Request for Additional Information No. 286 (3567, 3561, 3562, 3563), Revision 1

U. S. EPR Standard Design Certification

Docket No. 52-020

Application Section: FSAR Ch. 7

Figure 07.09-56-1—Example of the MSIs and GW connection to the Plant Data Network

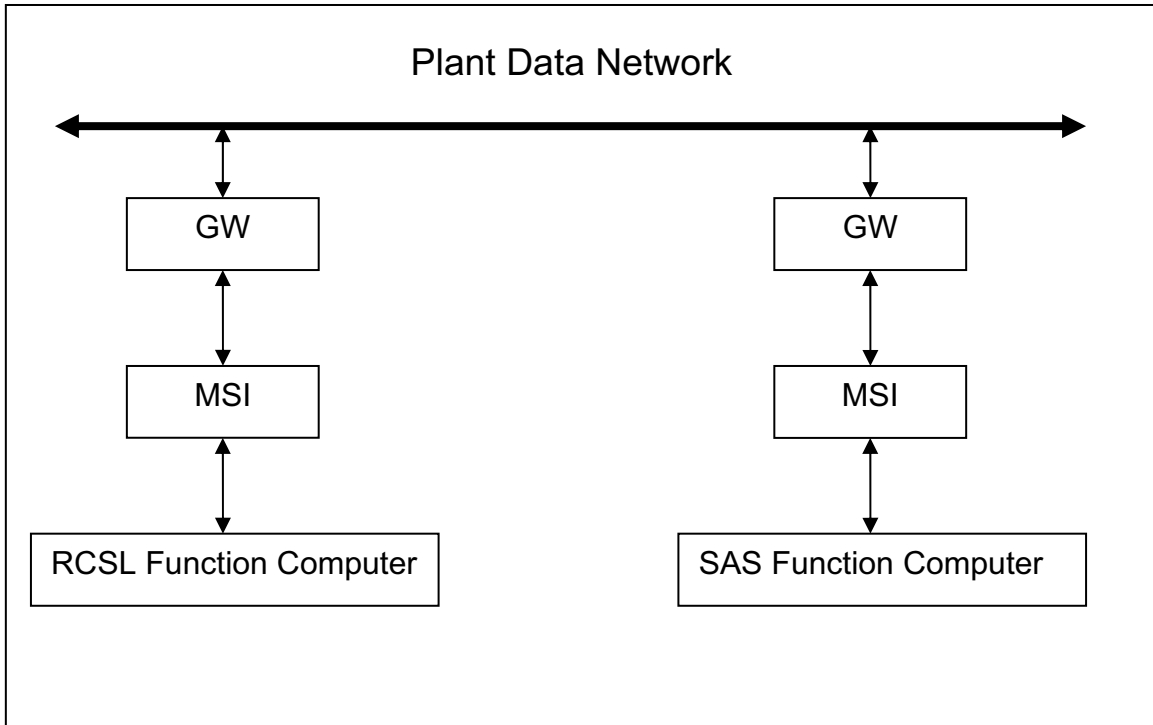
Clarify whether the non-safety related MSI within the RCSL is connected to the safety-related MSI within the SAS.

10 CFR 52.47(a)(2) requires, in part, a description of structures, systems, and components to permit an understanding of the system design and its relation to the safety evaluation. U.S. EPR DC-FSAR, Figure 7.1-7 and Figure 7.1-10 depict connections (e.g. M1-G1, M1-G2) from the safety-related MSI of the SAS to the non-safety related MSI of the RCSL. In addition, the non-safety related MSI of the RCSL is depicted as connected to the GW (e.g. GW1 via M1-G1) through the same connection as the one used for the safety-related MSI. Verify this depiction is accurate. In addition, describe why the non-safety related MSI needs to be connected to the safety related MSI from the SAS. Incorporate this information into the U.S. EPR DC-FSAR.

The gateways (GW) shown in U.S. EPR FSAR Tier 2, Figure 7.1-7 are physically different computers than the GWs shown in U.S. EPR FSAR Tier 2, Figure 7.1-10 (i.e., each Teleperm XS (TXS)-based system has its own GWs). The GWs are provided to interface the TXS system to the plant data network. There is not a connection between the reactor control, surveillance, and limitation (RCSL) monitoring service interface (MSI) and the safety automation system (SAS) MSI. Figure 07.09-56-1 illustrates this concept.
